BYTEK VW Expansion Project
1325 St. Laurent Blvd.
Ottawa, Ontario
Our Ref: 2301

Addendum N° 9

Date: January 23rd, 2025

Addendum #3

Proposed electrical room sketch

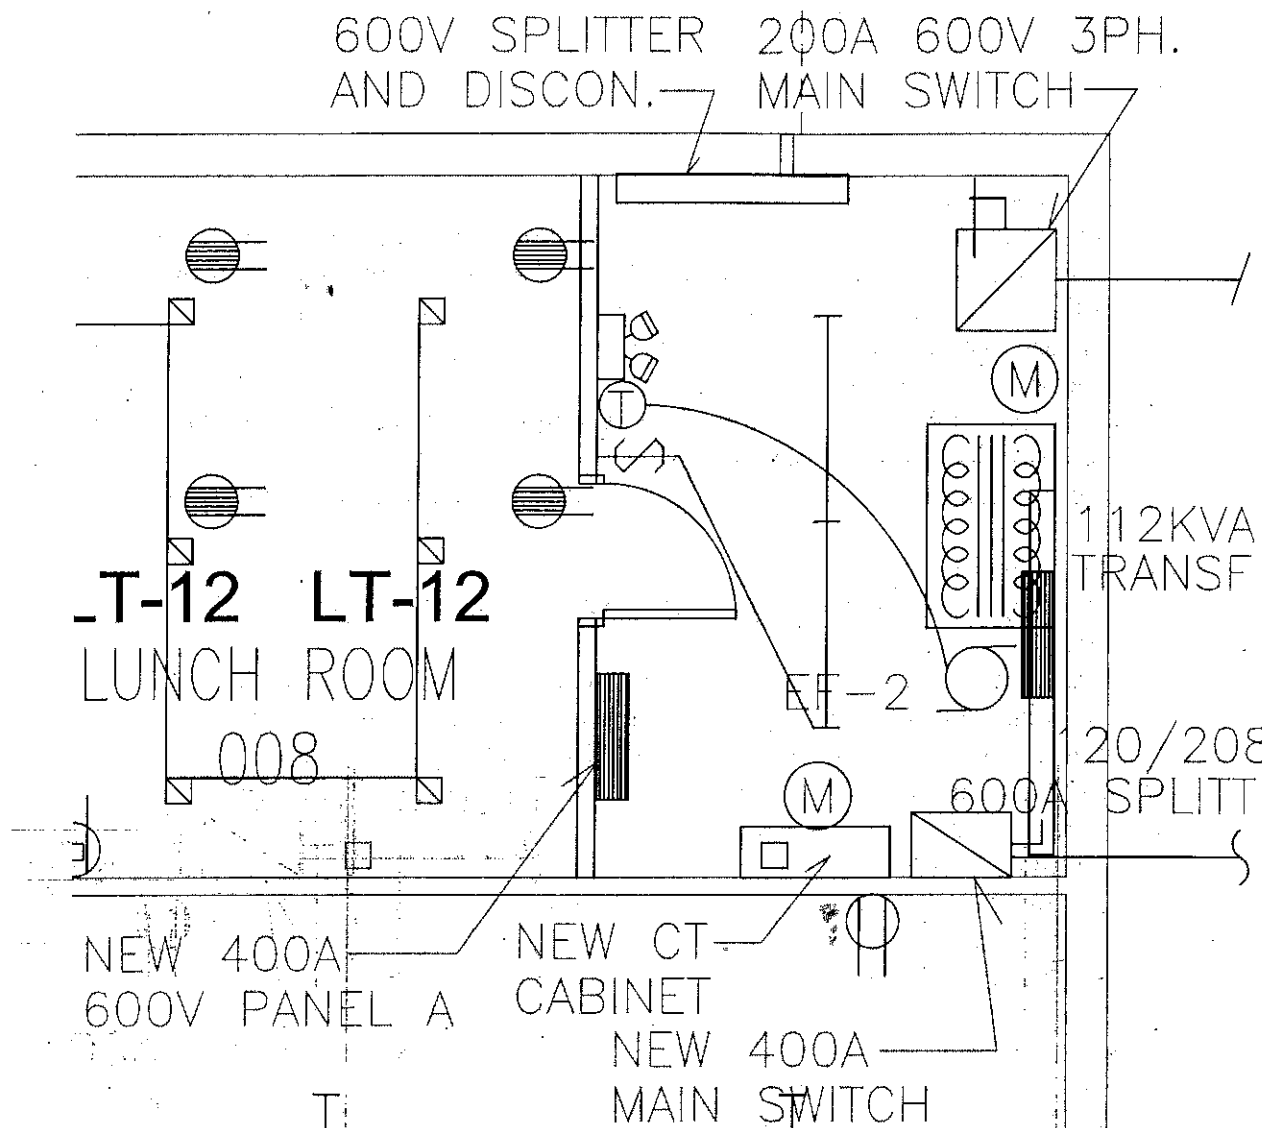
1. See DCD for light specifications on the light fixtures.
2. See proposed sketch for proposed electrical room. Existing electrical closets and doors to be removed. See proposed layout for new equipment.

3. Revise the single line drawing to delete the new 400A 600V splitter and feed Panel A directly. Provide a 200A breaker in panel A and refeed the existing 225A 600V splitter previously fed from the 200A main switch (deleted).
4. All new 600V loads to be fed from the new panel A. No panel schedule is being provided at this point.
5. All existing 120V loads to be fed from existing panels.

GROUND FLOOR PLUMBING

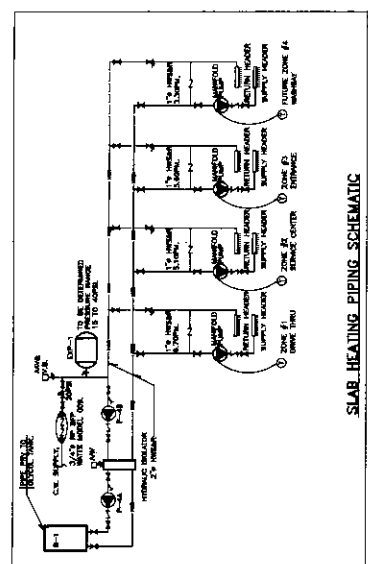
1. Plumbing fixtures types indicated for existing show room. Mop sink added to Janitors room.
2. Plumbing connection added for coffee maker c/w back flow in lounge.
3. Plumbing work in the Garage is pending the results of a camera inspection of the underground plumbing and may be included in a future addendum.

GROUND FLOOR
 H.V.A.C.

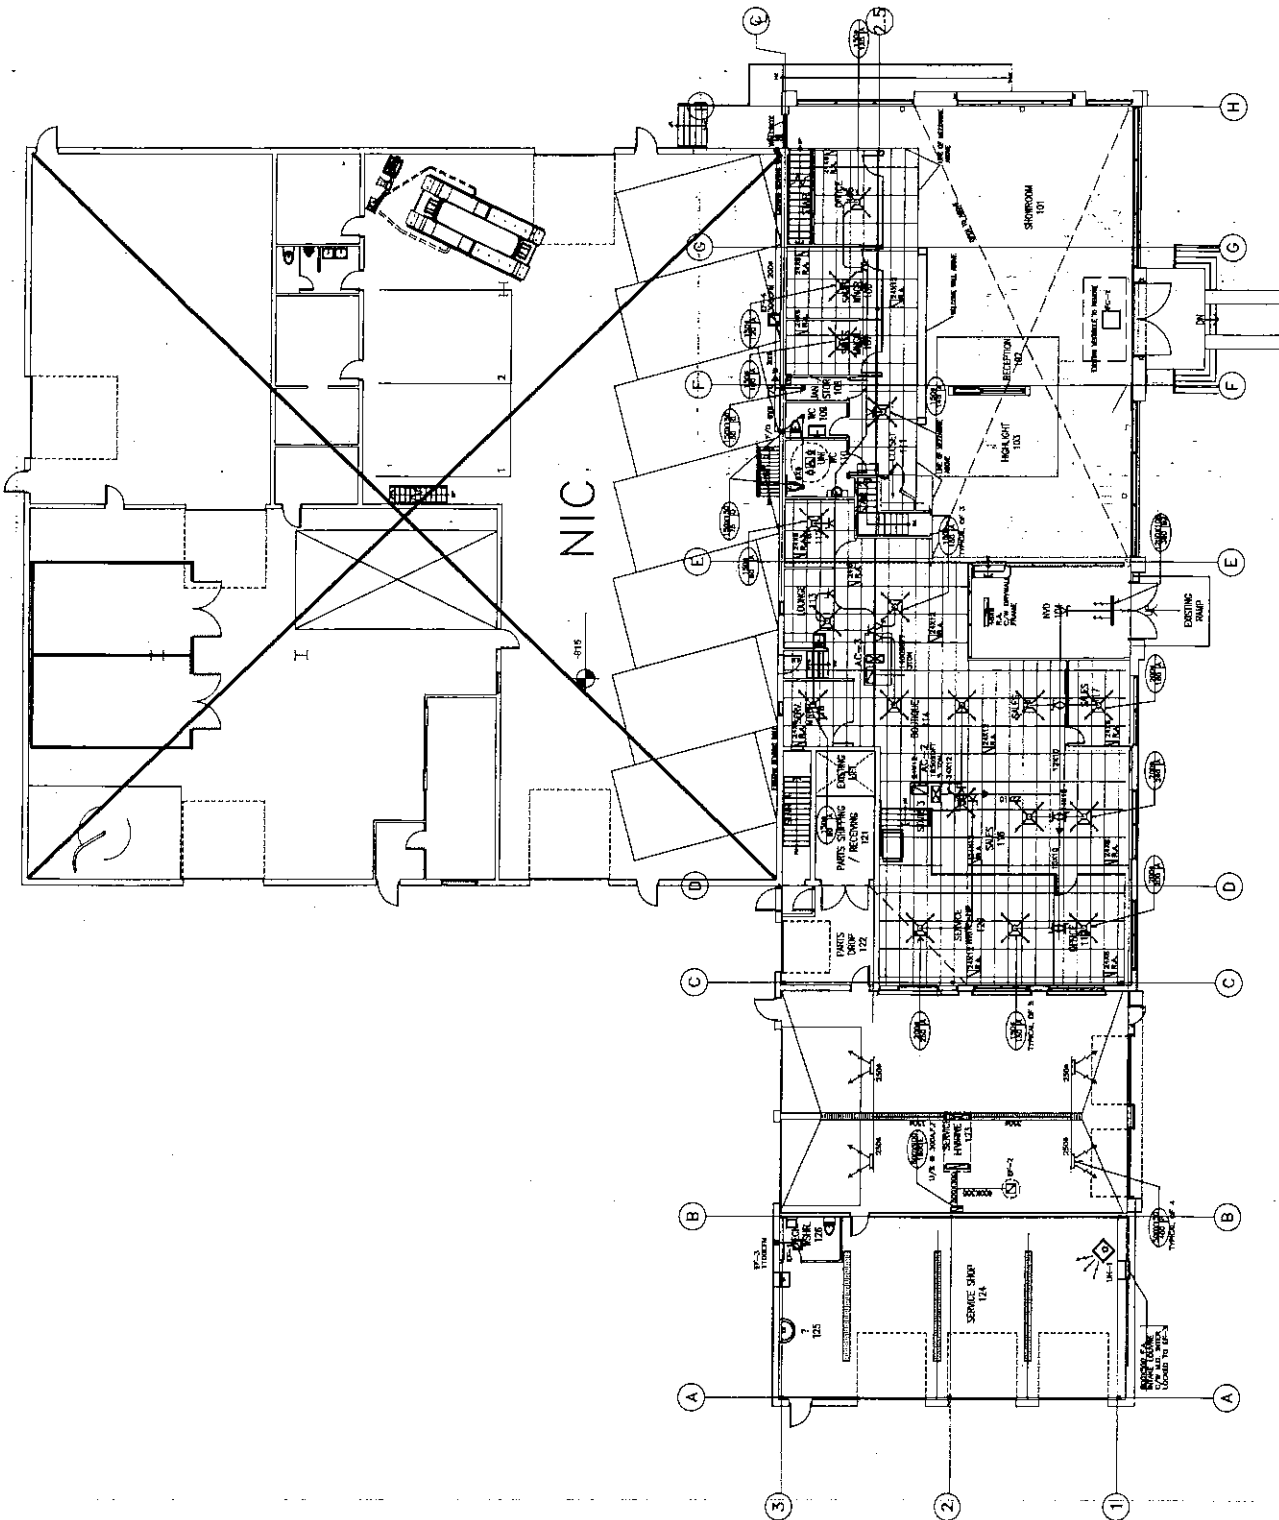
1. Duct sizes added to all new ductwork.
2. Return air grilles added to the space.
3. Exhaust fan EF-4 changed and is connected to basement washrooms.

MEZ-4 of 5
 MEZZANINE PLANS

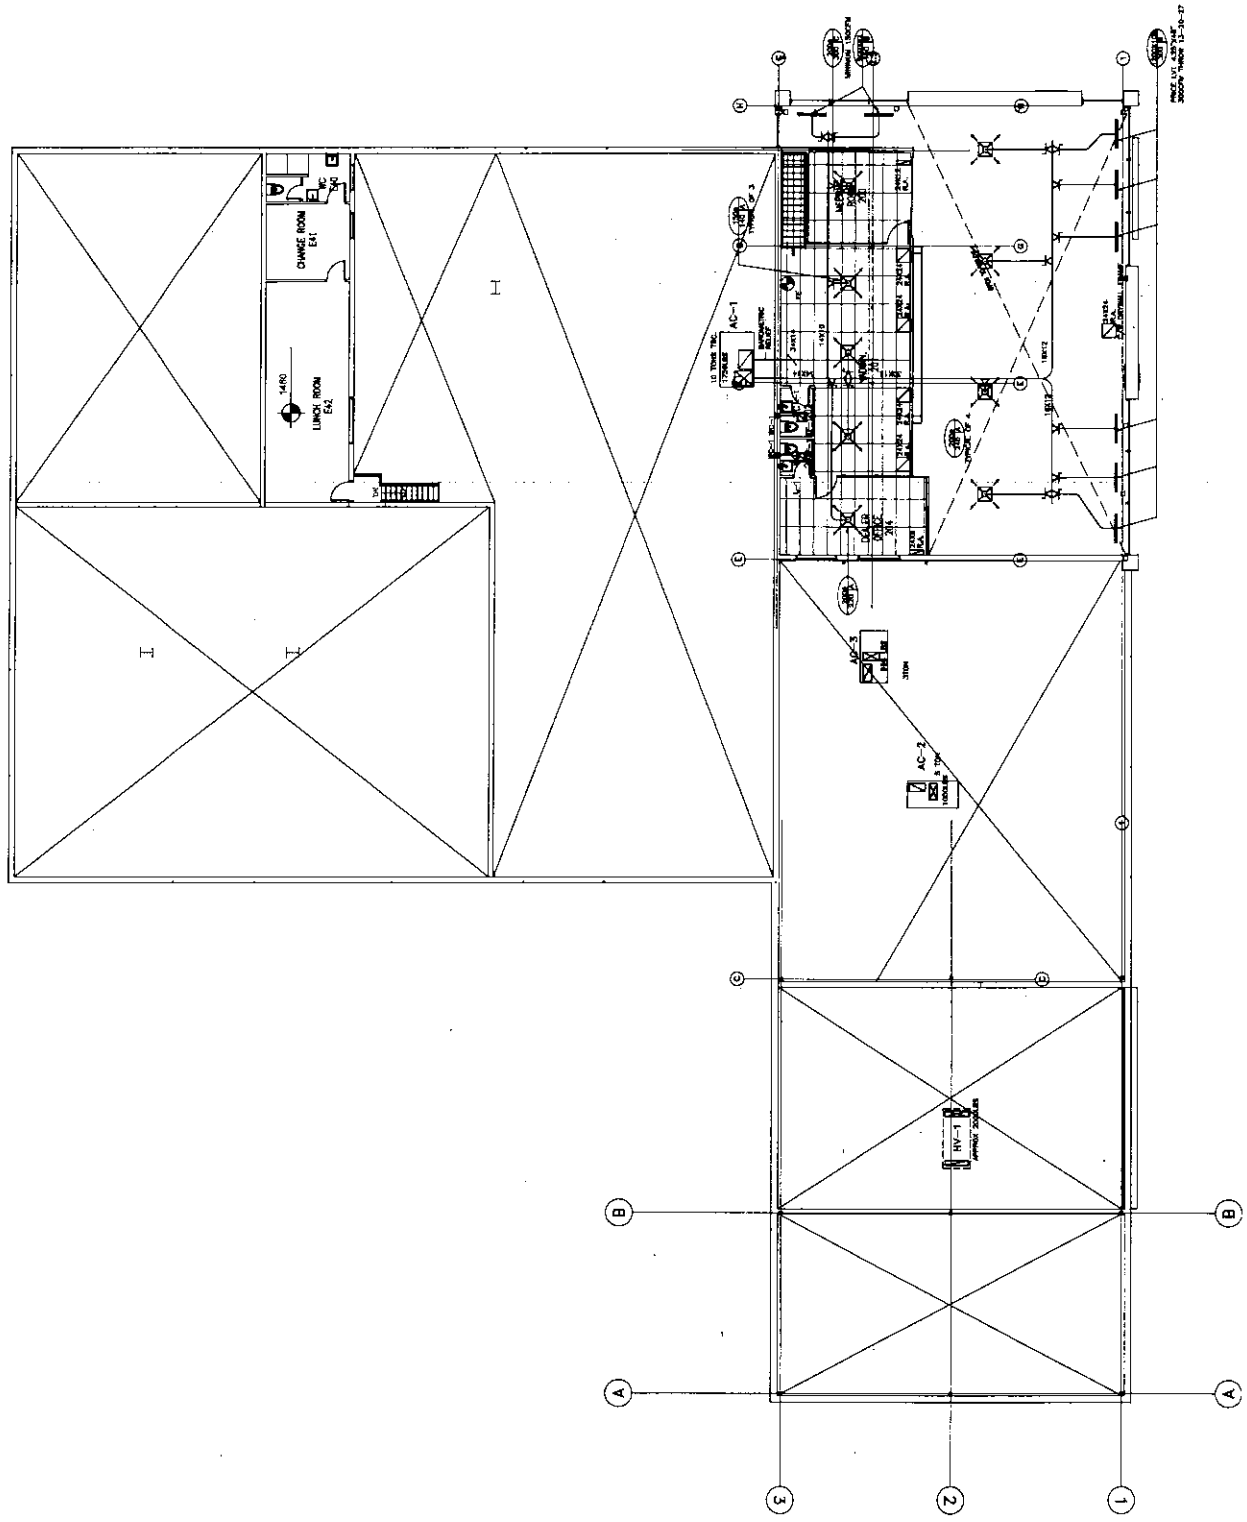
1. Ductwork sizes added, return air grilles added
2. New plumbing fixtures replacing the existing in washroom
